Product Change Notification - LIAL-31LFQR391

CCB 4255 Initial Notice: Qualification of GTK as a new assembly site for selected Atmel AT27C0xx device families available in 32L PDIP (.600in) package.

CCB 4255
Pre and Post Change Summary
PCN# LIAL-31LFQR391

Tube Drawing

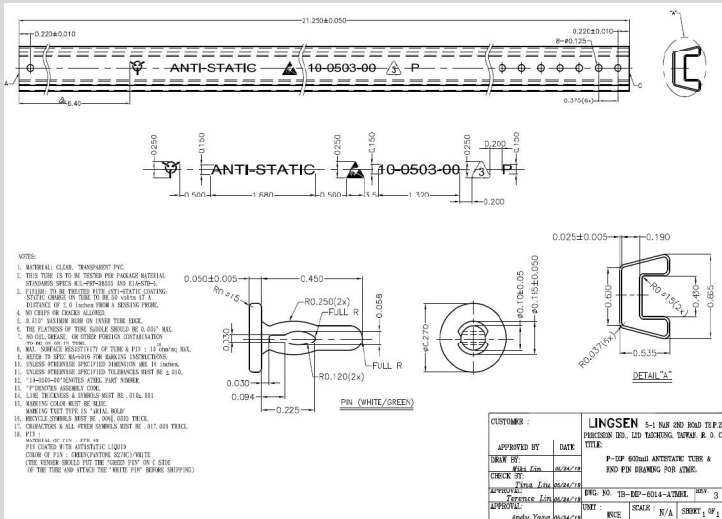
Lead frame material		A194	A194
Packing media (Tube)	Base Quantity Multiple (BQM)	12	12
	Tube Color	Clear	Clear
	Plug Color	White / Green	White / Blue
	Tube Dimension and (Length)	Minor dimensional changes. See pre and post change comparison	
	Tube Drawing	See pre and post change comparison

Package	Lead Count	Body Size	Units/Tube	Length (inch)	End Plugs
PDIP	32	600 mils	12	20.250+/- 0.050	White/Green

PRE-CHANGE (LPI)

Tube Drawing

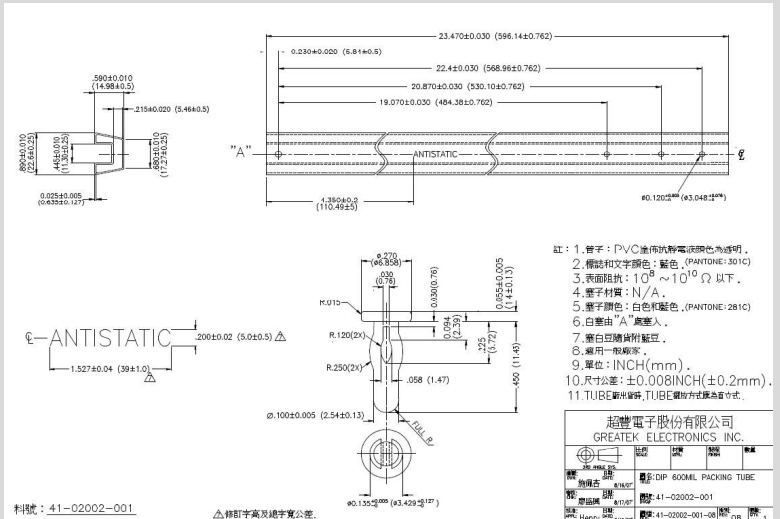
Package	Lead Count	Body Size	Units/Tube	Length (inch)	End Plugs
PDIP	32	600 mils	12	23.47+/- 0.030	White/Blue

POST-CHANGE (GTK)
